## Part B – Item 3.1 - Lot 115 (No. 14) TYRELL STREET, NEDLANDS – RESIDENTIAL FOUR GROUPED DWELLINGS

### Form 1 – Responsible Authority Report (Regulation 12)

<b>DAP Name:</b>	Metro Inner Development Assessment Panel	
<b>Local Government Area:</b>	City of Nedlands	
<b>Applicant:</b>	CF Town Planning & Development	
<b>Owner:</b>	J Woodford & C M Woodford	
<b>Value of Development:</b>	\$3,636,363 million <input type="checkbox"/> Mandatory (Regulation 5) <input checked="" type="checkbox"/> Opt In (Regulation 6)	
<b>Responsible Authority:</b>	City of Nedlands	
<b>Authorising Officer:</b>	Bruce Thompson	
<b>LG Reference:</b>	DA25-102435	
<b>DAP File No:</b>	DAP/25/02894	
<b>Application Received Date:</b>	15 April 2025	
<b>Report Due Date:</b>	3 September 2025	
<b>Application Statutory Process Timeframe:</b>	90 Days with an additional 51 days agreed	
<b>Attachment(s):</b>	1. Location Plan 2. Development Plans received 1 September 2025 3. Submissions 4. Design Review Panel Minutes 5. Applicant Planning Report (7 April 2025) 6. Applicant Response to Submissions (30 June 2025) 7. Landscaping Plan received 28 July 2025

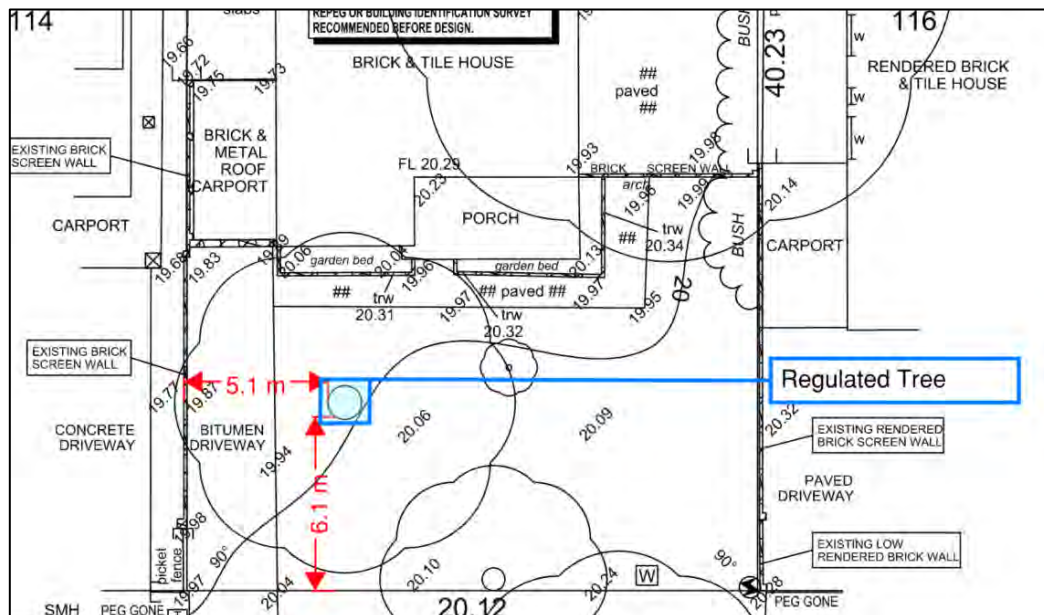
The site survey accompanying the development application depicts several large trees on site. At the time of writing, only one of these trees remains on site. The tree in question is located towards the front of the lot and appears to be a jacaranda mimosifolia with a height of approximately 6m and a canopy diameter of approximately 7m. The tree is defined as a 'regulated tree' as the canopy diameter is in excess of 6m.

It would be unfeasible to redesign this development to accommodate the retention of the tree due to its location. The tree is located a notable distance from the lot boundaries to the extent that this would require the development to provide unreasonable side and front setbacks to maintain the tree.

The preservation of the tree would require, at a minimum, a side lot boundary setback of approximately 7m and a front setback of approximately 8m to provide a clearance of at least 2m from the base of the tree trunk (the minimum distance required to ensure that the footings of the building and any soil compaction did not harm the tree). Expecting or imposing setbacks of this distance on a residential lot 171m<sup>2</sup> in size with a density code of R60 is considered unreasonable and a significant site constraint given the development potential and expectation of the density code. As such the re-design of the dwelling to preserve the tree is not considered feasible and the removal of the tree is acceptable.

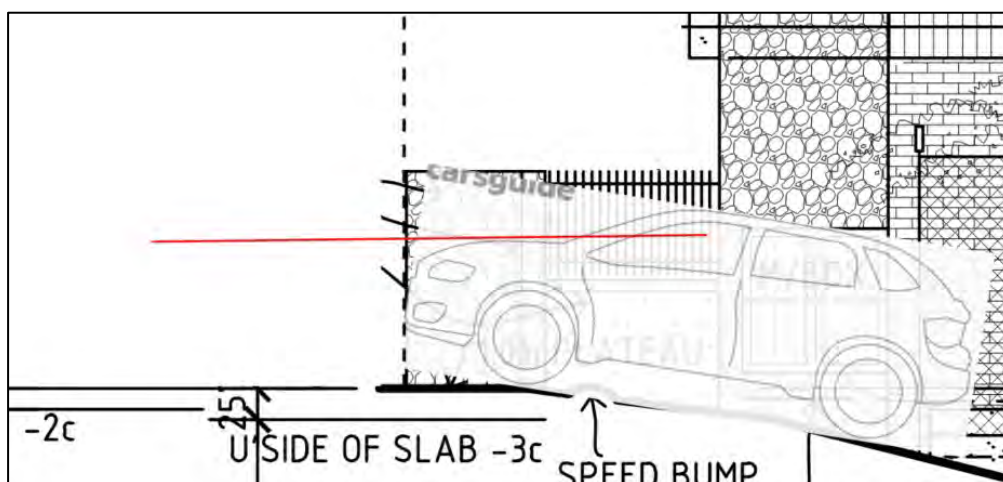
Lots 1 and 2 are comprised of 12.9% deep soil area as opposed to the deemed-to-comply 15%. Further, lots 1 and 2 provide a minimum of 4.4m<sup>2</sup> of deep soil area to support the growth of the secondary small trees in the courtyard areas. Design principles for landscaping consider whether landscaping enhances the streetscape, contributes to the amenity of the development and provides sufficient deep soil area to support tree growth.

- The landscaping provided by the development will contribute to the streetscape. The proposal features two small trees as well as low level planting within the front setback, visible from the street.

- The landscaping provided across the site enhances the amenity of the private open spaces of each dwelling. The ground floors feature planting areas adjacent to the front verandahs, within the small courtyard areas adjacent to bedroom 2, along the common access driveway and at the termination of the communal driveway at the top of the staircase. Lots 1 and 2 also feature on-structure planting within the balcony on the first storey to provide a varied, green outlook from the upper floor bedrooms.

- A minimum of 4.4m<sup>2</sup> deep soil area is provided on lots 1 and 2 to support the growth of the second small tree in the courtyard. A small tree is defined as a tree with a canopy diameter of 2m to 6m. Given that 9m<sup>2</sup> is the recommended deep soil area for a small tree, it is acknowledged that each tree may not reach its maximum potential in regard to height and canopy diameter, however, 4.4m<sup>2</sup> is still sufficient soil area to support a tree that achieves at least a 1.5m canopy diameter and 2.5m height.

#### *Upper Floor Walls*

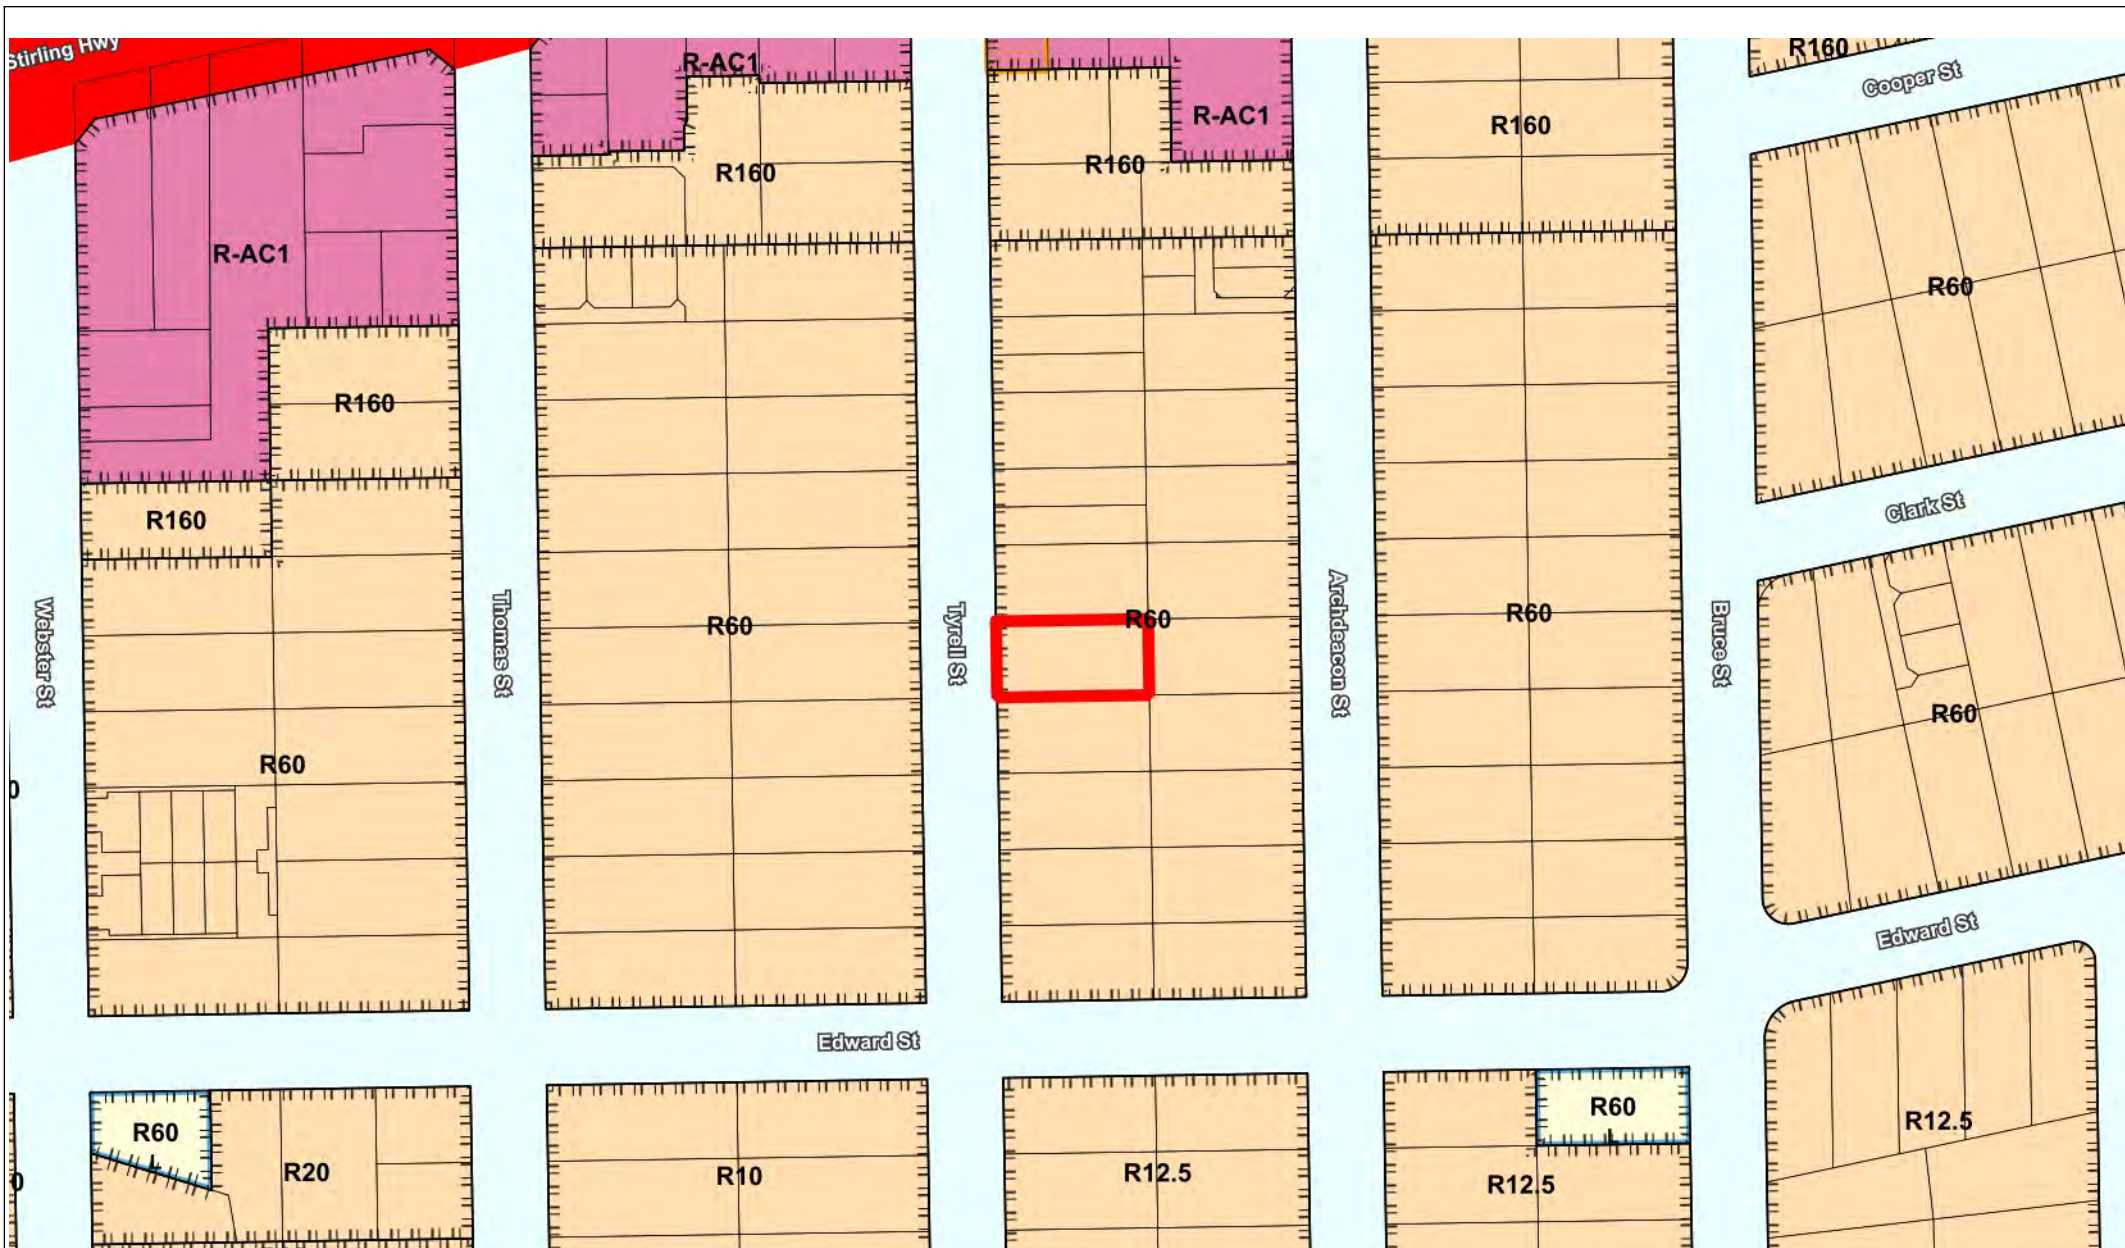
The upper floor walls across all dwellings are proposed to be set back a minimum of 1.2m from the side lot boundaries in lieu of the deemed-to-comply 1.5m.

- Due to the slope of the land down towards the rear of the lot, the walls' height varies from 5.2m to 6m. These wall heights are typical of upper storey walls observed in the Tyrell Street locality and could even be considered lower than the expected height of walls in the R60 code, where three storey development is contemplated. Many of the contemporary houses in the area feature articulation in upper storey walls. The development complements this design pattern by incorporating articulated upper floor walls to the lot boundaries. The walls feature three different setback distances which vary from a minimum of 1.5m to a maximum of 3.2m.
